Customer Service Bulletin
Commercial Business Group

MultiPro® Foam Marker Kit

Subject: **Performance Issues with Foam Marker Kit.**

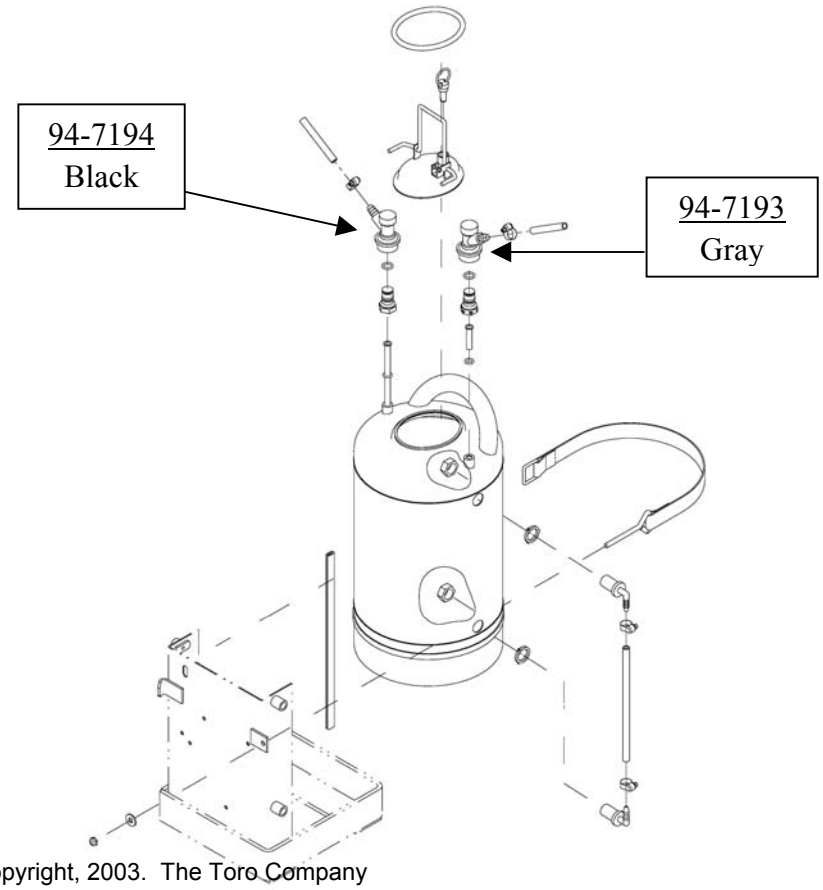
SITUATION: The Foam Marker tank Fittings (94-7193) and (94-7194) may be installed in reverse locations. Fittings installed incorrectly can create poor foam quantity and quality.

CORRECTION: If a performance issue is noted, inspect the Foam Marker Tank fittings for correct orientation as shown below.
